K9 Resorts Exterior Elevations and Signage

STAFF REPORT

2020-0001 ARB

Request: The agent, on behalf of the owner, is requesting Architectural Review Board (ARB) approval of exterior elevations and signage with technical deviations for the K9 Resorts located within Commerce Park East.

1 - FRONT ELEVATION

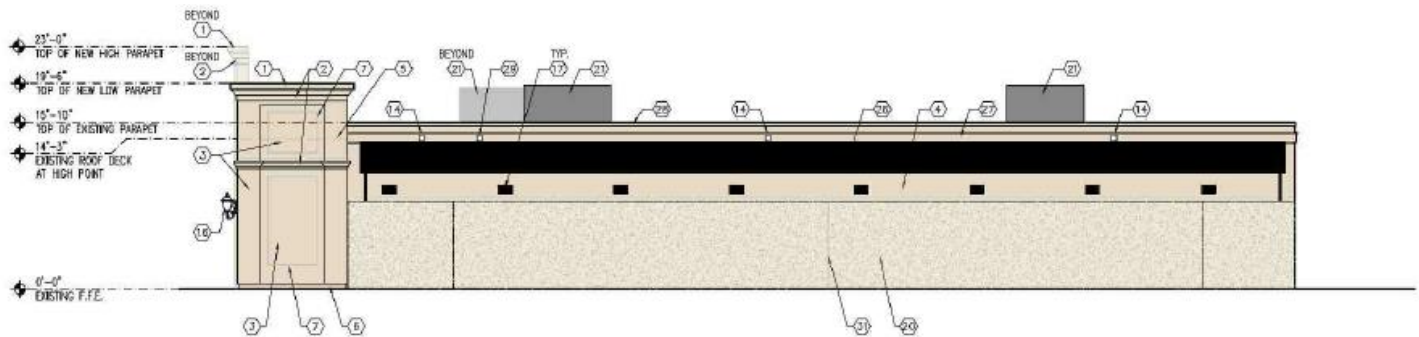
Staff does recommend incorporating another color into the front elevation either lighter or darker along the banding, columns, or within the sign area to break up the elevation.

Response: Based on Section 6.4.4.B.1 above, architectural detail was only required on the front (east) façade. The north façade is buffered by a landscape buffer, mature trees, and foundation planting, and the south and east facades are adjacent to other industrial land uses. The east and south also incorporate play yards with eight (8) foot walls and required hedging that will break up the facades. The existing front façade has very minimal architectural detail. Scoring, banding, windows, columns, and signage break up the front façade so that there is limited blank wall space. They also incorporated decorative black anodized grilles in front of the arched front door and windows making a unique entrance.

Response: The exterior façade as it exists today meets only one of the design treatments above – providing canopies. The proposed elevations provides a side canopy, raised cornice and banding, arches, display windows, ornamental/structural architectural details, and a projected and covered entry.

Response: Being that this building was built prior to the regulation above, this does not apply to the retrofit of this building. However, this retrofit added a parapet that is 3 ½ feet above the dominant roof condition. There is no additional room on the 80 foot front façade to incorporate another roof change as the other sides of the building do not have to follow the above regulation.

Body:	K9 Resorts Custom Beige
Stucco and EIFS:	<u>A more contrasting color from the body, either lighter or darker, then the proposed cream color.</u>
Paint Finish:	Non-Glossy – owner is proposing semi-gloss, but will need to change to a finish that is non-glossy.
Door/Window Frames:	Black Anodized Aluminum
Walls:	Eight (8) foot CBS walls
Awning:	Black or Cobalt Blue (to match signage) fabric
Lighting:	Black and/or bronze finish

3 - EXTERIOR SIDE YARD ELEVATION

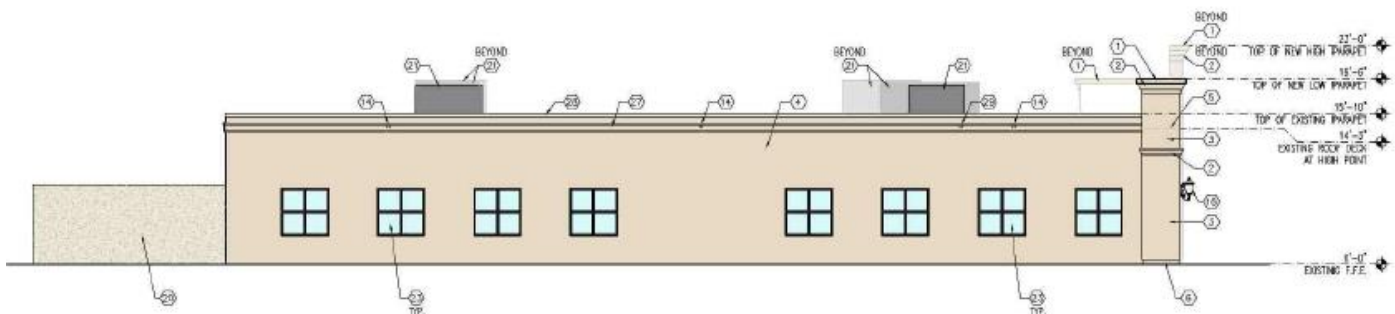
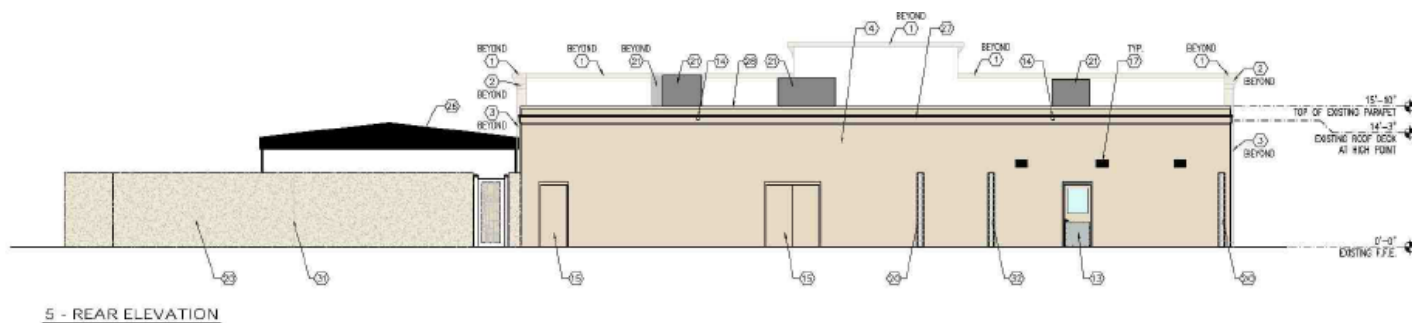
Per Section 6.4.1.6, equipment located on a roof shall be screened with a parapet or enclosure that aesthetically blends the equipment with the building. Based on the elevations shown in Exhibit D – Proposed Elevations, the equipment is only being screened from view from the front façade. The applicant is requesting not to install screening as they are surrounded by other industrial uses and a lake. Staff is recommending the applicant submit a roof plan showing that equipment is screened from view at 10 feet above grade 200 feet from the building. If the equipment is visible, screening to match the color of the building will be required. This standard applies to all structures throughout the Village.

7. All roof top mechanical equipment shall be screened from view on all sides. The equipment shall not be visibly seen at 10 feet above grade 200 feet from the structure. A roof plan shall be submitted to ensure the roof equipment is not visible prior to submitting for building permit. If visible, screening must be installed.

Major Tenant Primary Wall Signs:

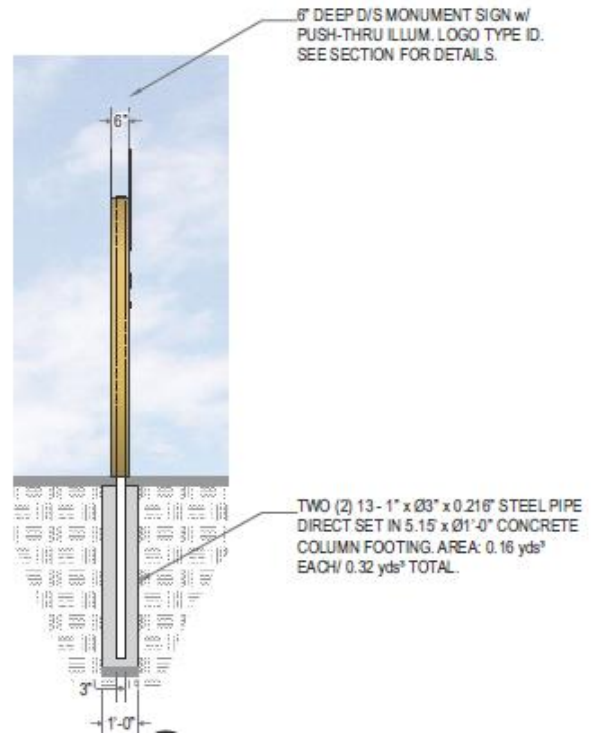
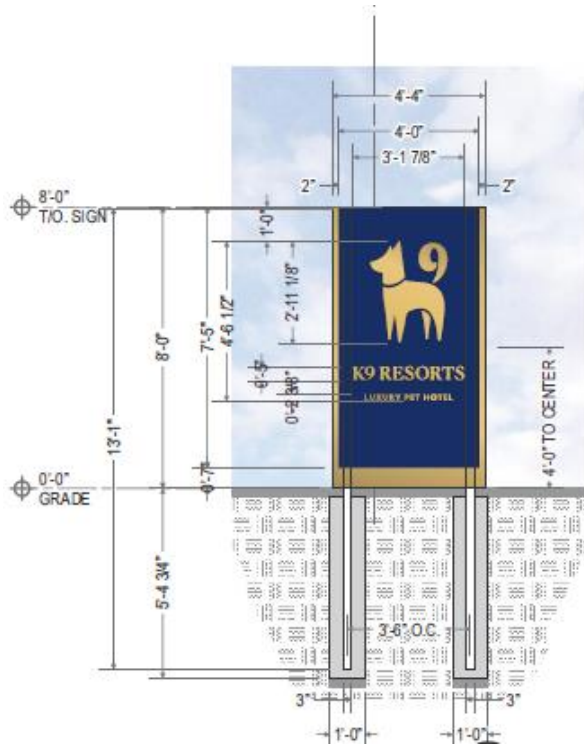
Per Section 7.9.7.A.1.b and c, institutional uses shall only have one (1) primary wall sign (Sign A) a maximum of 66 inches in height, length not to exceed 80% of the primary façade, and a maximum sign area of two (2) feet per foot of the primary façade length. The applicant is requesting a technical deviation to allow two (2) additional primary wall signs (Sign B and C) on the west façade. All wall signs are pin-mounted, halo lit illuminated in brushed brass. See technical deviation justification below.

1. Describe in detail the Technical Deviation.
 - a. Wall Signs – the applicant is requesting two (2) additional primary wall signs on the front/west façade. Per Section 7.9.7.A.1.b, major tenants are permitted one (1) primary wall sign. Per Section 7.9.7.A.1.d.i, tenants are also permitted to have two (2) additional secondary wall signs located on the rear, end, and/or tower facades with only one (1) sign on each façade. Secondary wall signs shall not exceed 50% of the maximum sign area of the associated principal wall sign. The proposed wall signs, on the same elevation, are the following sizes:

The maximum sign area permitted for the one (1) primary wall is two (2) square feet per foot of the principal façade length not to exceed 150 square feet. The façade length is 81 feet which means the maximum sign area of the one (1) principal wall sign can be 150 square feet. The total sign area of the three wall signs together equals 52.21 square feet which is 1/3 the size of what is permitted.

2. The primary wall sign (Sign A) shall comply with the proposed sign shown in Exhibit G – Proposed Signage and meet the following requirements:
 - a. Maximum Total Sign Area – 38.33 square feet
 - b. Maximum Height – 5 feet
 - c. Maximum Length – 7 feet 8 inches
3. The secondary wall sign (Sign B) shall comply with the proposed sign shown in Exhibit G – Proposed Signage and meet the following requirements:
 - a. Maximum Total Sign Area – 7.94 square feet
 - b. Maximum Height – 9 inches
 - c. Maximum Length – 10 feet 7 inches
4. The secondary wall sign (Sign C) shall comply with the proposed sign shown in Exhibit G – Proposed Signage and meet the following requirements:
 - a. Maximum Total Sign Area – 5.94 square feet
 - b. Maximum Height – 9 inches
 - c. Maximum Length – 7 feet 11 inches

Monument Sign:

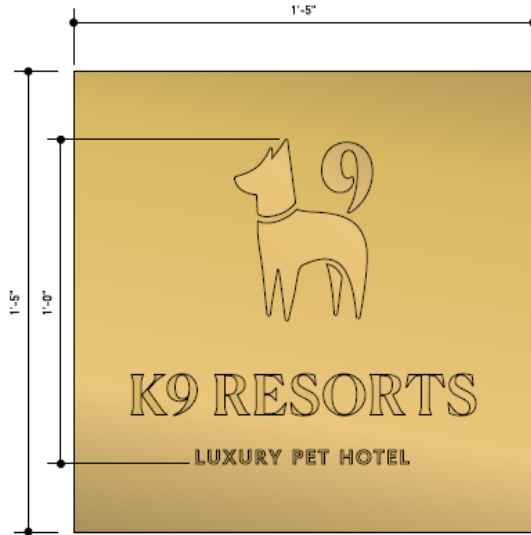
Per Section 7.9.7.B.2, an industrial use may have one (1) small monument sign for a single tenant. The monument sign shall be a maximum of eight (8) feet tall in height, copy not to exceed 36 inches in height, two (2) lines of copy, and sign area not to exceed 32 square feet. The proposed monument sign meets height requirements but exceeds the sign area, copy height, and lines of copy and requires a technical deviation. See technical deviation justification below.

- b. Monument Wall Sign – The sign copy exceeds the maximum height, sign area, and lines of copy permitted.

Per Section 7.9.7.B.2.b., the maximum sign copy height is 36 inches. The majority of the copy is taken up by the logo and large spacing between each line of copy. Without spacing in between each line, the copy would only be 3 feet 7 inches in height. The sign exceeds the sign area by 2.66 square feet. Staff recommends the sign stay within the 32 square feet which means reducing the width of the sign 4 inches.

5. The monument sign shall meet the following requirements:
 - a. Maximum Height – 8 feet
 - b. Maximum Length – 4 feet (proposed sign reduced by 4 inches)

- c. Maximum Sign Copy Height – 36 inches
 - d. Maximum Lines of Copy – 3
 - e. Sign Area – 32 feet
6. The address identification/numbering height for the building shall comply with the Palm Beach County Fire Code minimum requirements and shall not exceed the LDR maximums.
